**MODIFICATION REQUEST:
CBD and South East Light Rail
Various Design Modifications (MOD 1)**

Secretary's
Environmental Assessment Report
Section 115ZI(2) of the
Environmental Planning and Assessment Act 1979

February 2015

Figure 2: Realignment of Light Rail and Proposed Royal Randwick Stop

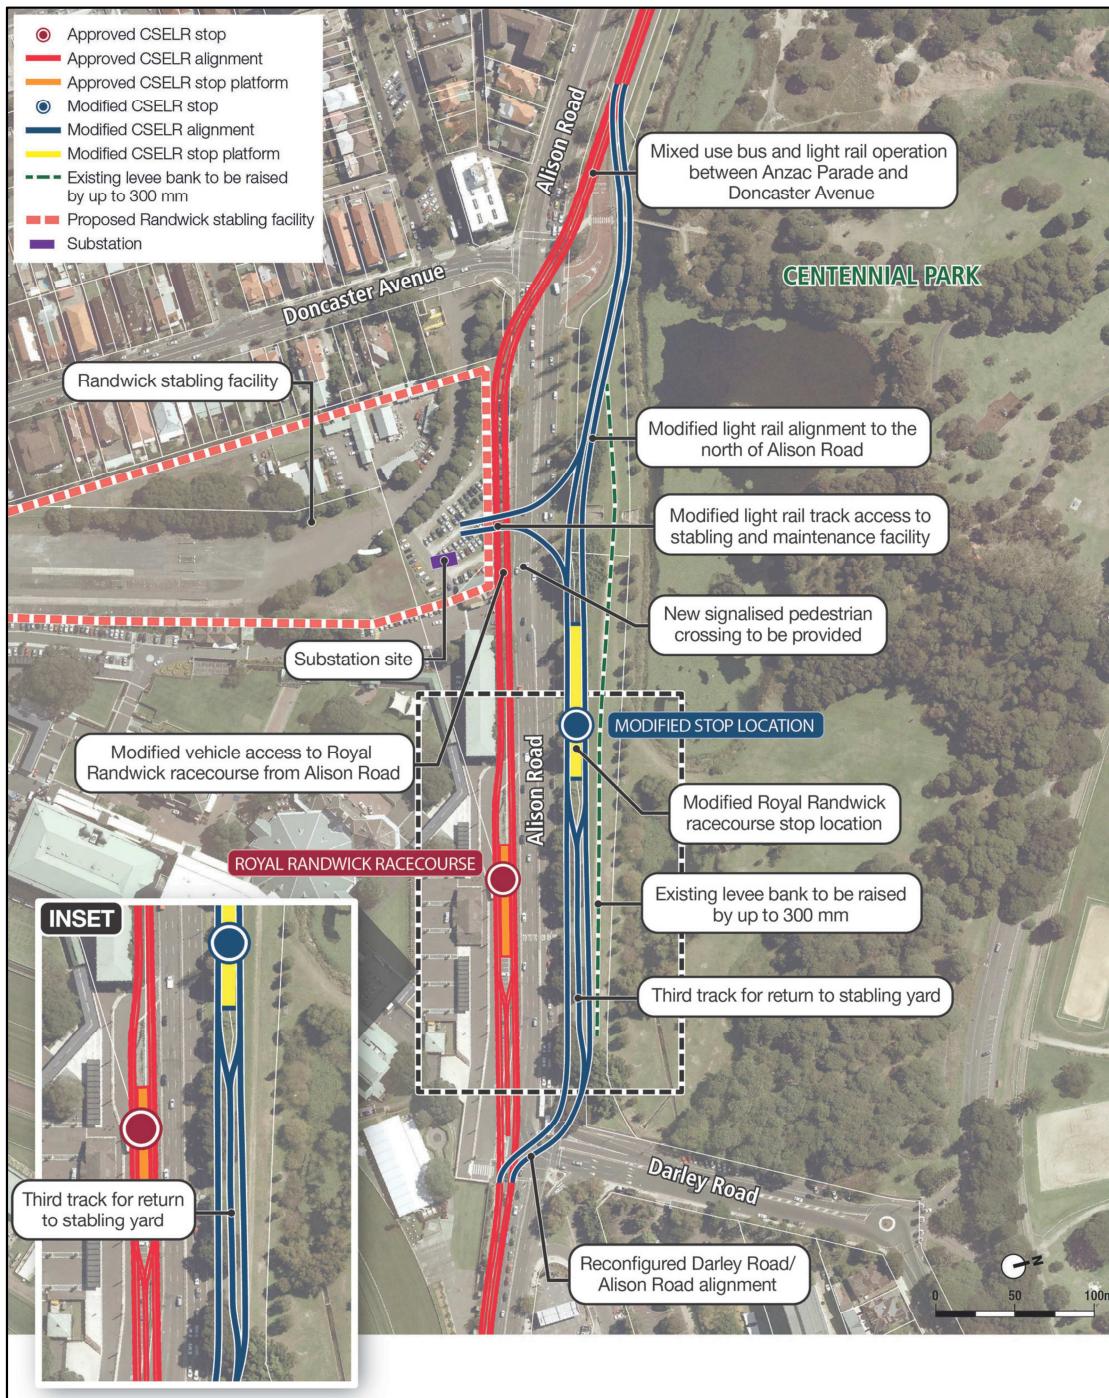
The revised alignment would follow the northern side of Alison Road from its point of diversion approximately 100 metres east of Doncaster Avenue. The alignment then crosses to the southern side of Alison Road at the Darley Road intersection before continuing along the approved alignment to Randwick.

An existing 1,100 metre flood levee adjacent to the realigned route would be raised by up to 300 millimetres along its length to reduce flood frequency to the stabling facility. This would reduce the flood mitigation works on the stabling facility site. A new retaining wall approximately 200 metres long and up to three metres high would be required along the central portion of the modified alignment.

The Department, Randwick City Council and University of NSW queried if it would be beneficial to move the stop further east on the revised alignment and closer to Darley Road. TfNSW advised that this was not possible as a third track/turnback is required in this area to enable services to return to Central during special event services. The Department accepts this response.

The Department raised concerns for the safety of light rail users from the racecourse crossing Alison Road directly from the racecourse gates opposite the revised stop location and not the designated crossing approximately 200 metres towards Doncaster Avenue. Additionally, concern was raised regarding the capacity of the platform to safely accommodate a significant influx of passengers following special events.

Natural instinct would be for racegoers to exit the Alison Road gates and take the most direct route across Alison Road to the stop rather than via the pedestrian crossing. TfNSW advised that existing fencing at the racecourse gates and on the Alison Road median would be retained to provide a deterrent to this behaviour by directing pedestrians towards the designated crossing points. The new footpaths leading to the stop would provide for queuing while passengers wait for the next services. It is acknowledged that the existing fencing, as well as the bus facility outside the gates, would provide a significant barrier or deterrent. Whilst the Department accepts that these measures are in place, it is noted that there has been no obvious destination on the northern side of the road to attract users to cross at that point.

Figure 3: Centennial Park Master Plan 2040 (November 2013)

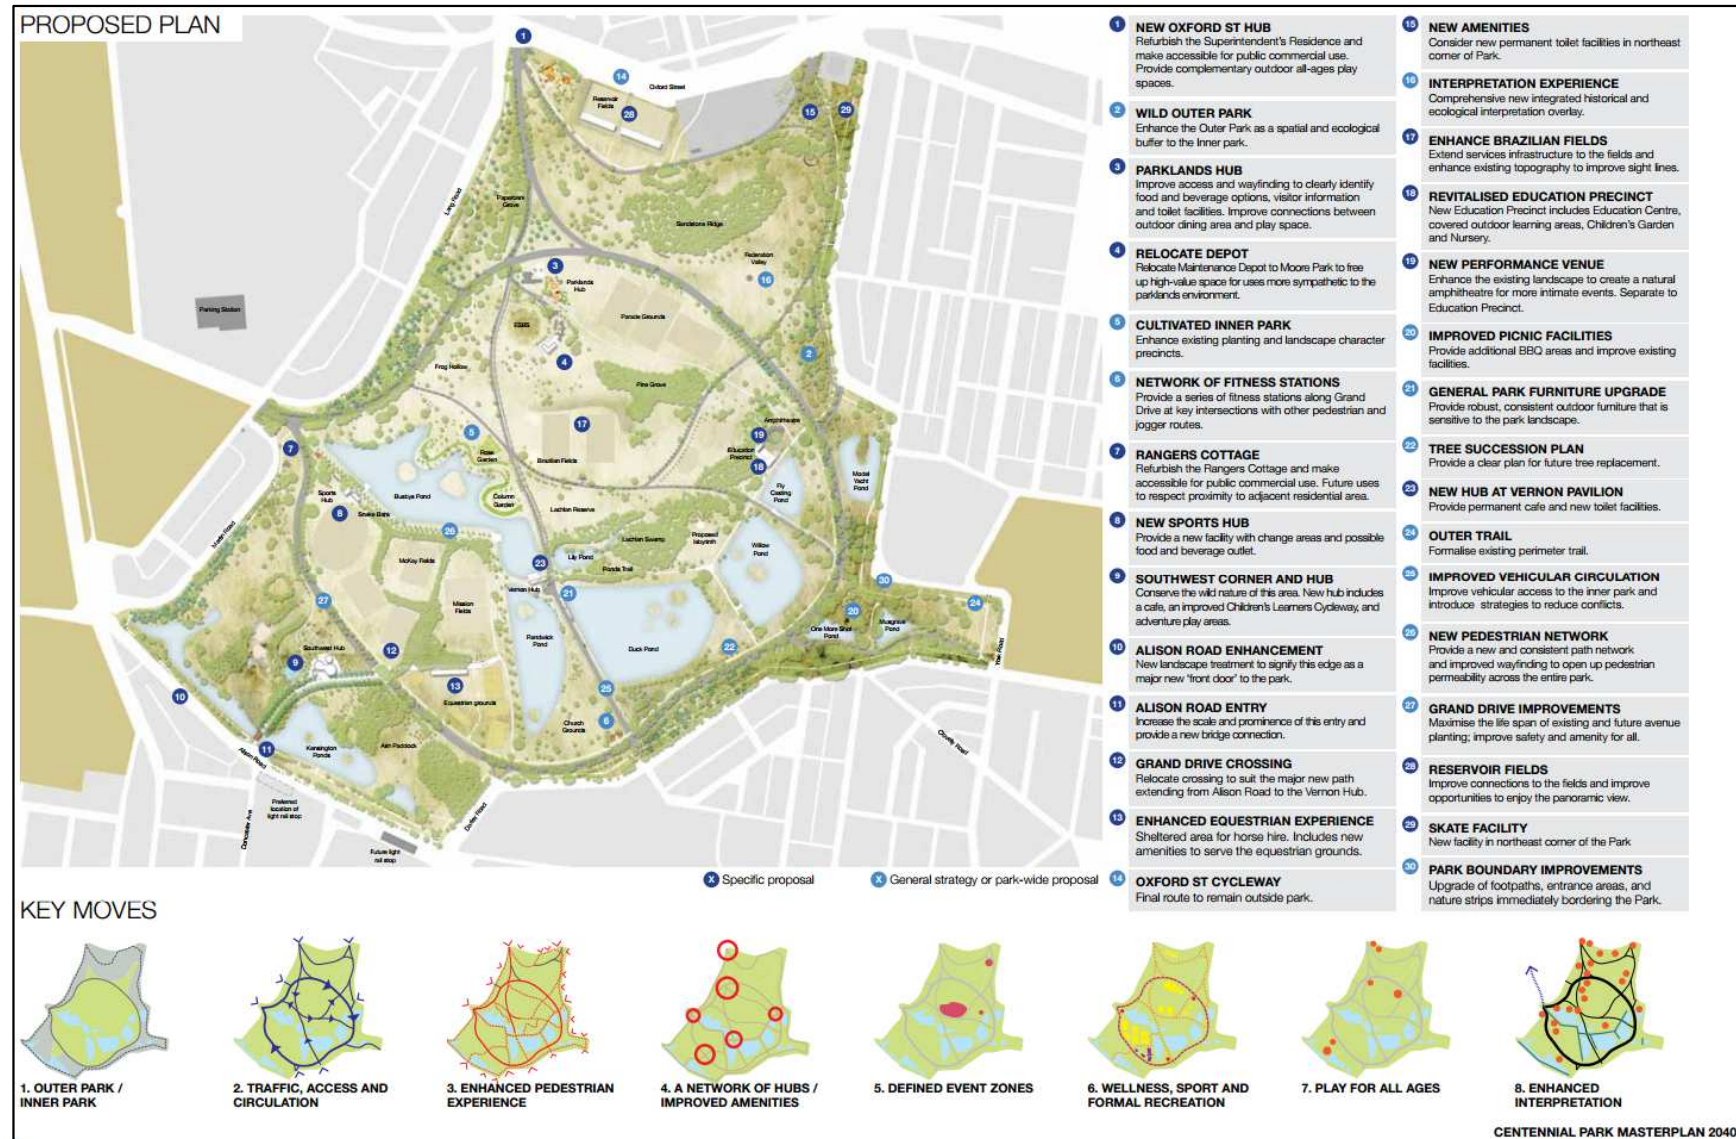
The Centennial Park and Moore Park Trust stated that this entry is critical and provides the most logical and practical access from the Doncaster Avenue residential precinct and will increase in importance over time with the proposed increase in residential densities planned for the Randwick/Kensington area. Notwithstanding the efforts to integrate with the proposed light rail, the master plan would have been completed prior to the modification. Centennial Park and Moore Park Trust has requested that TfNSW provide funding and resources as required to revise the master plan and provide a replacement entrance to the park.

The Department accepts that the modified alignment may impact on the proposed Alison Road entrance to require relocating or the Alison Road entrance, particularly due to access for pedestrians accessing from the Doncaster Road crossing that will now have to cross the existing busway, light rail alignment and shared path. However, the modified stop location could benefit the park to a significant degree and further reinforce the location of this entrance as it is located at the western end of the relocated stop and passengers would have direct access to it.

The Department concurs that TfNSW should provide funding or resources, to an amount agreed with Centennial Park and Moore Park Trust, to review the master plan and identify those components that will require revision as a result of the modified light rail alignment along Alison Road. Where these can be clearly attributable to the modified alignment, TfNSW should bear costs for construction or implementation of those items to the extent of its liability. The Department has recommended that a condition be inserted into the project approval to this effect.

Figure 4: Proposed modification to Moore Park stop

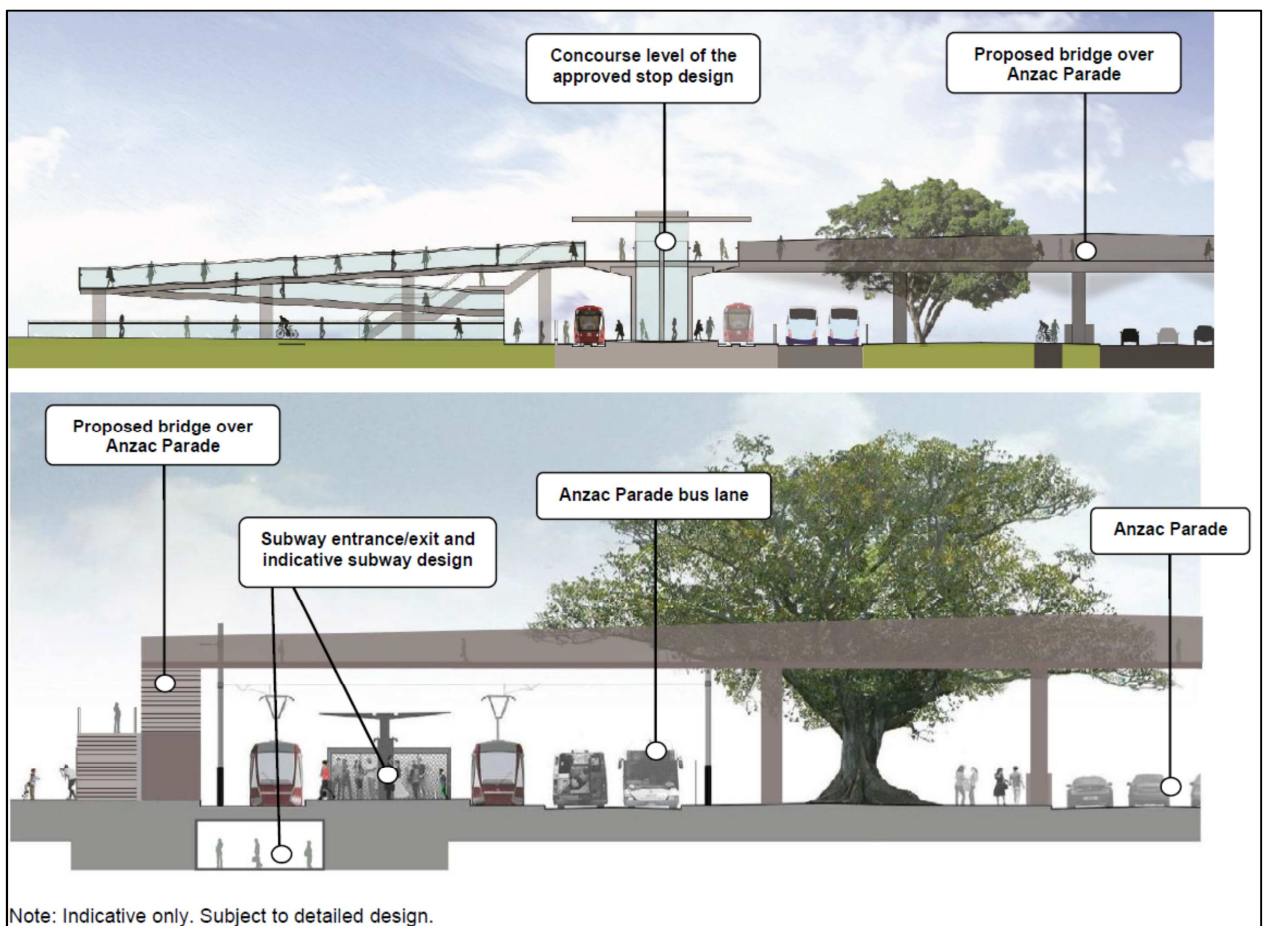
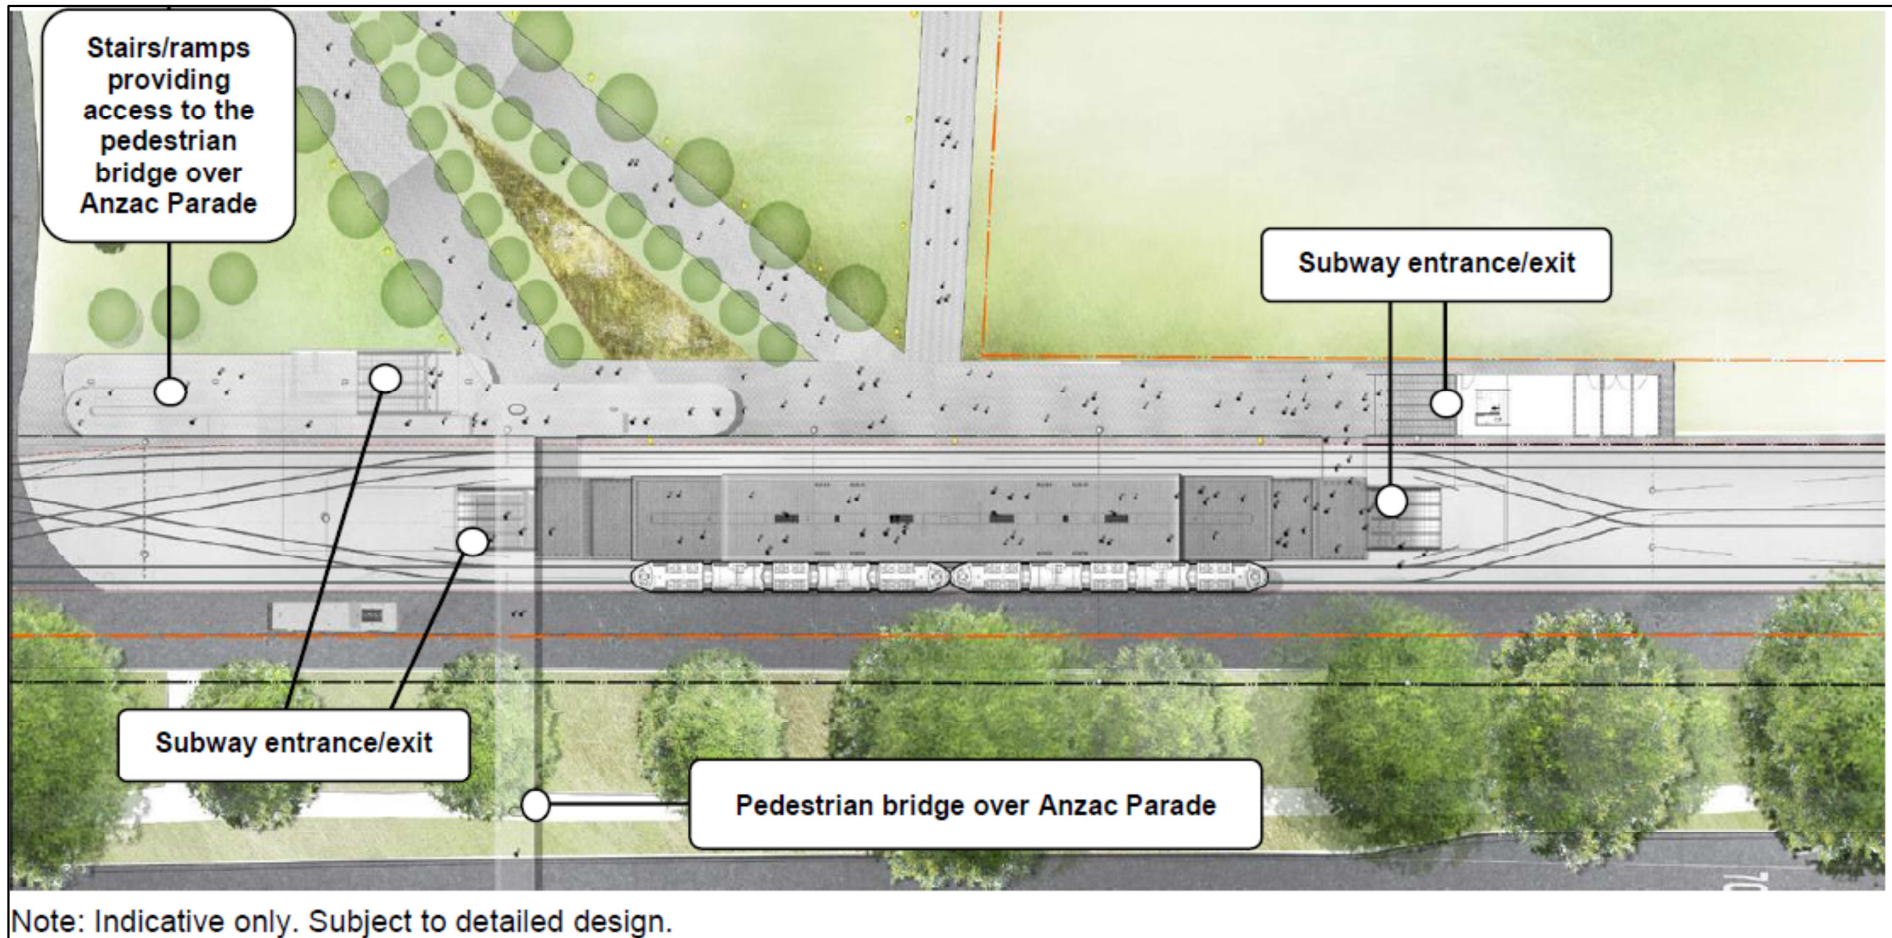
As such, access to the approved pedestrian bridge over Anzac Parade would be modified to include new ramps and stairs at the eastern end of the bridge. These ramps and stairs were previously included in the design of the approved Moore Park stop but now form part of the bridge structure.

The Department considers that the modified design of the Moore Park stop would provide visual benefits when compared to the approved project as the bulk and scale of the structure has been reduced by eliminating the concourse level. Safety is a key issue for the Department and government overall wants to ensure that the project is safe for all users, including commuters or students accessing Sydney Girls and Sydney Boys High Schools.

Existing condition B27 requires stop access and design plans to be prepared and implemented to ensure safety, connectivity, efficiency and convenience is maximised. The added requirement to undertake independent safety audits as part of this condition will ensure that student safety is paramount. While the Department is confident that this can be achieved with the existing conditions and the Proponent's additional commitment, it has recommended inserting another condition that the Proponent be required to prepare a safety case which demonstrates to the satisfaction of the National Rail Safety Regulator, that children can safely access the Moore Park stop during peak start and finish times where direct access from the Anzac Parade pedestrian bridge to the Moore Park stop cannot be provided.

Figure 6: Proposed circulation of passengers at the Moore Park stop

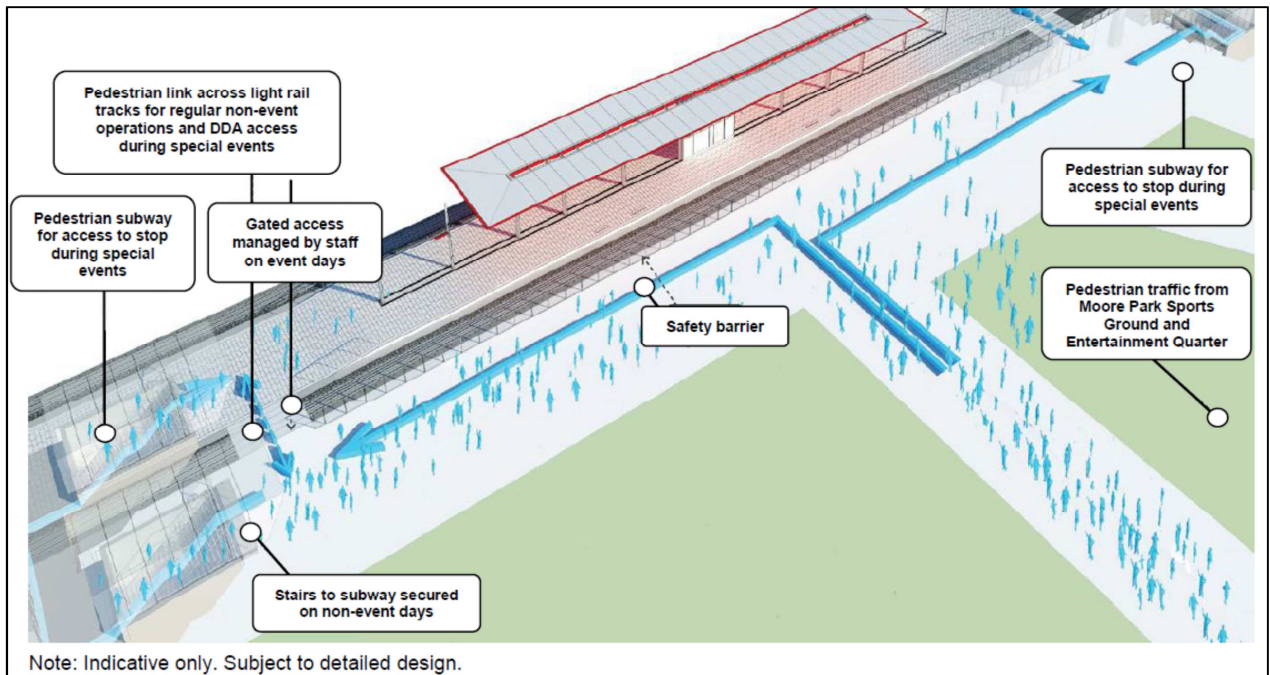
Staffed guard rails and gates would control access during special events to direct passengers to the centre of the stop. An indicative plan showing the proposed passenger circulation patterns are shown on **Figure 6**.

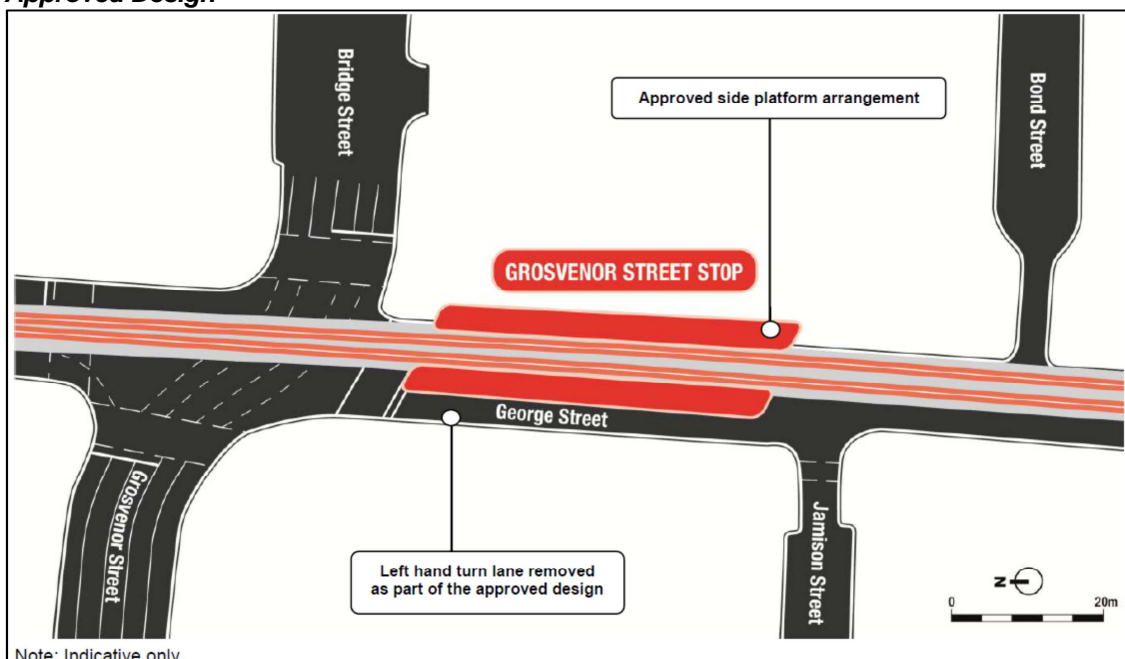
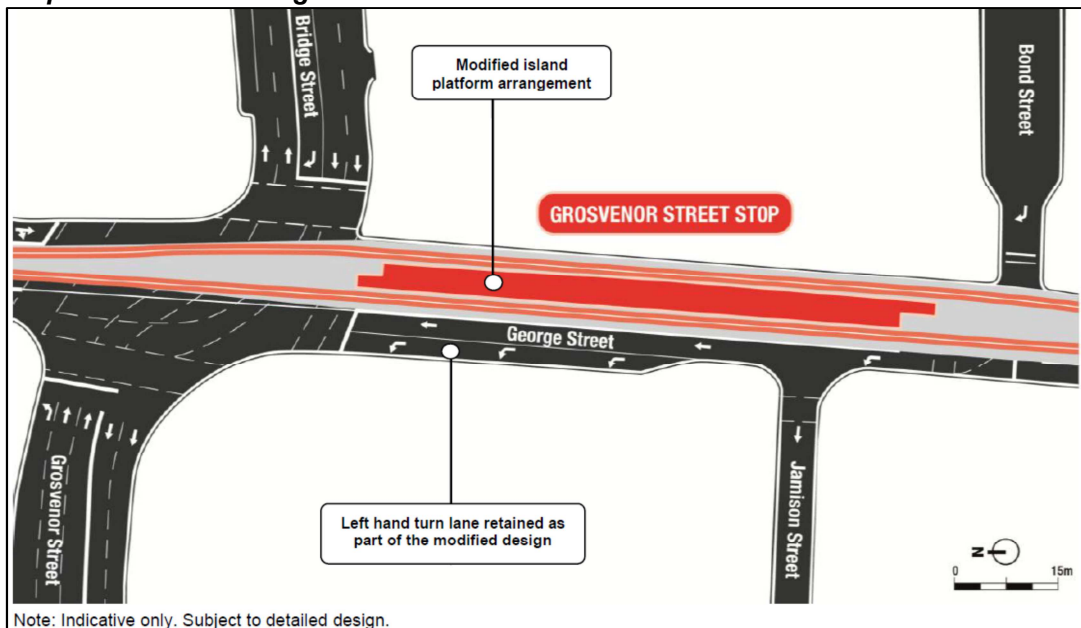
The Department acknowledges the need to undertake flood mitigation works on site and the need to provide at grade access for light rail vehicles to the stabling facility from Alison Road. The Department raised concerns that alternatives to reduce the height of the silo above the stipulated maximum did not appear to have been considered.

The Proponent subsequently advised that alternatives were considered but that the main driver for the silo height is the clearance required over the light rail vehicle and committed to further investigation during detailed design to reduce the height and design of the silo or have two smaller silos. The Department is satisfied that this is an issue that can be resolved through detailed design.

Despite the above assessment, it is considered that the maximum height of 10.5 metres above the existing ground level for all buildings and structures within the facility be maintained with the exception of the sand silo where it can be demonstrated, to the satisfaction of the Secretary, that the sand silo cannot be redesigned to meet that restriction. An amendment to this effect is recommended. It is important to note that the Department has only permitted the height of the sand silo to be increased (where it can meet the modified requirements of the condition) and not all structures so as to limit the visual impact of the facility and maintain the existing requirements of the approved project.
